CO-011: Solar Fence Orientation — Upright to Laid Down

Rodriguez Residence · Oak Valley Estates Lot 5 · Kanarraville, UT

CO NUMBER	DATE	CONTRACTOR
CO-011	March 21, 2026	TBD

PANEL ASSEMBLY — LAID DOWN (LANDSCAPE)

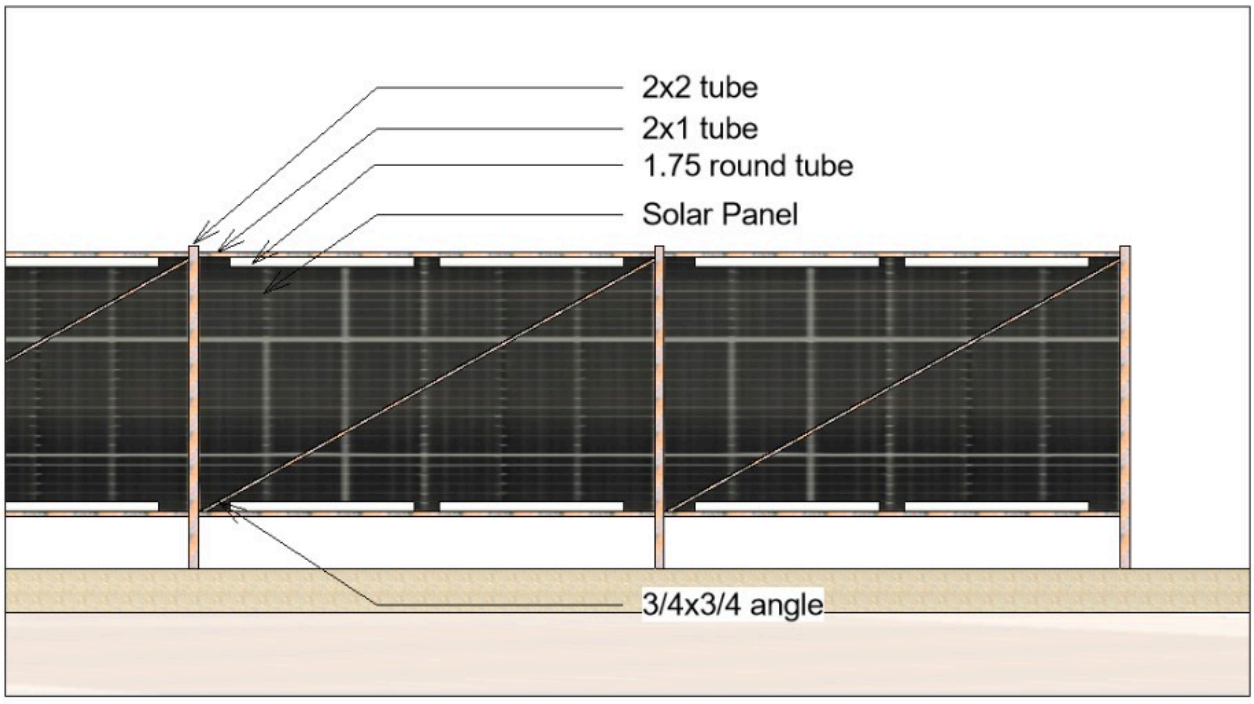
Change Summary: Modify the solar fence panel orientation from **upright (portrait)** to **laid down (landscape)**. Panels will be rotated 90° so the long dimension runs horizontally along the fence line.

- Rotate EG-NT66 705W panels from vertical (portrait) to horizontal (landscape) mounting.
- Adjust frame structure: 2×1 tube top/bottom rails and 2×2 vertical posts to accommodate landscape panel dimensions (2384mm × 1303mm laid down).
- Revise diagonal bracing (3/4×3/4×1/4 angle) as required for new orientation.
- Update junction box / cable routing — conductors on long edges (top and bottom rails) run full length to combiner at vault end.
- Coordination with electrical scope: DC conductor routing, combiner location, and conduit stub-ups remain per existing design unless otherwise revised.

- Panel dimensions (landscape): 2384mm (93.86") × 1303mm (51.30") × 33mm frame.
- 30 panels in one straight line; ~71.5m (234.6') total horizontal run.
- Bifacial panels (BF) — East/West facing benefits from rear-side irradiance when laid down.
